Reviewer1

We would like to thank the reviewer for the thorough review and provided comments. In the following, we list all the reviewer raised issues and provide an answer. We have indicated, if and what the changes were to the manuscript.

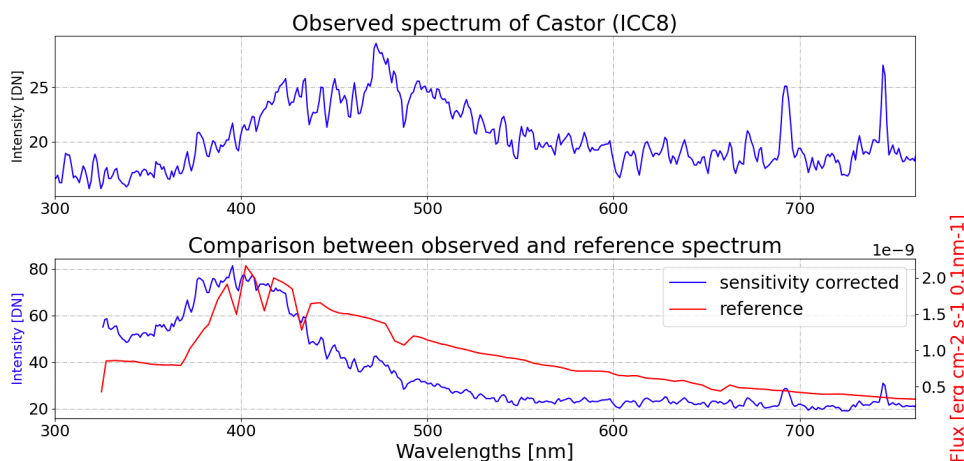
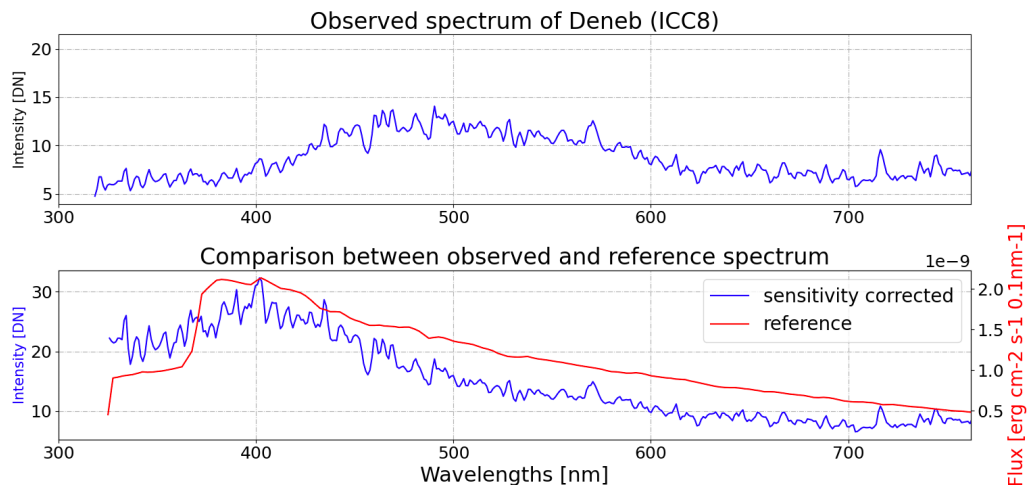
Line 187: “when compared to the spectra provided in CALSPEC or Hyperleda: “It would be interesting to report on the outcome or include a picture with the results.”

A: We are not sure if this would really fit inside this paper. It might even justify a conference paper ... let’s see.

Anyhow, if the reviewer would like to see an example, we provide on of the images here.

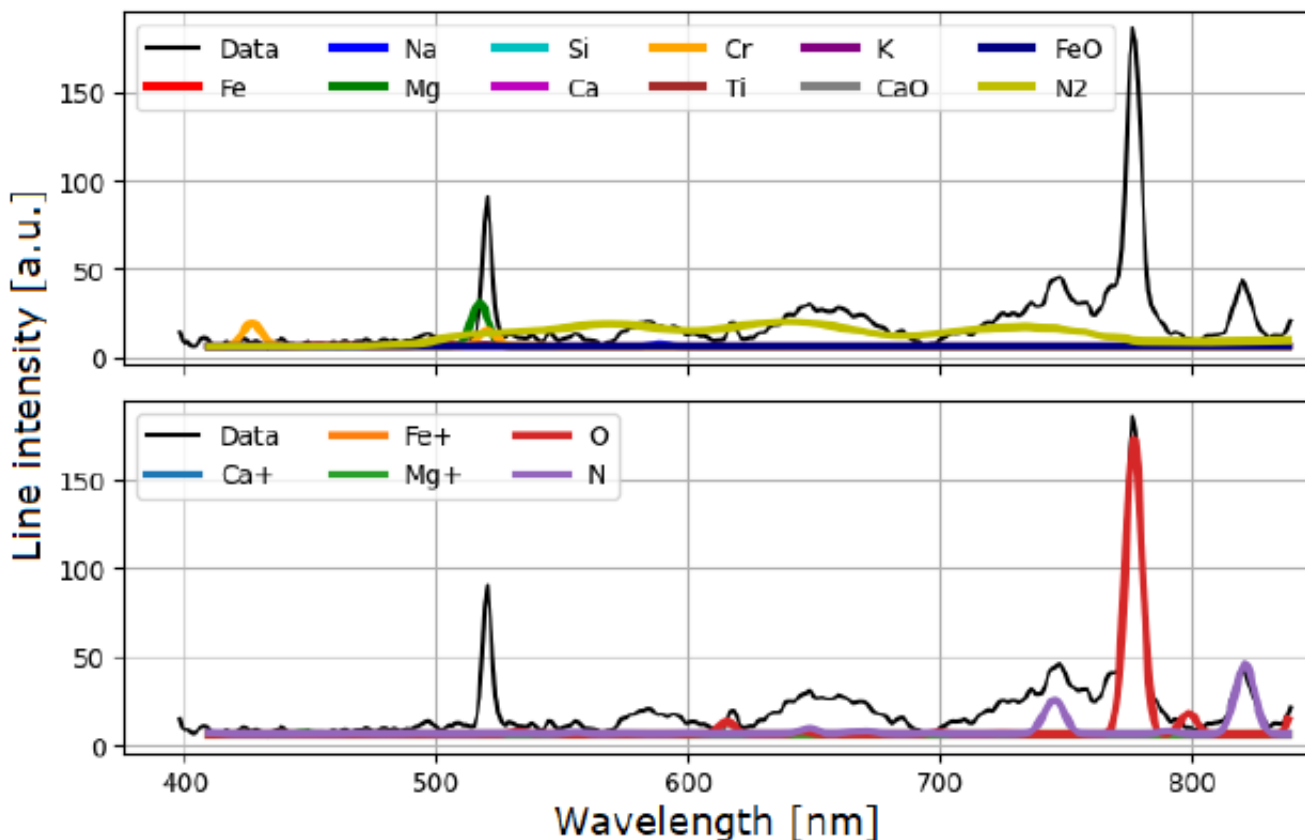
Figure 8: “Question: is also thermal radiation included in the PARADE simulation? If not how is the continuum formed?”

Thermal radiation is considered in the PARADE simulation, please see Loehle et al. 2021 for more detail, especially Section II.

The manuscript was modified at the end of section 7.1 to include the following sentence:

“The modelled spectra include the contribution of the Planck background at the individual temperatures.”

Below is an example to show an example clearly demonstrating the N₂ background contribution to the overall spectrum.
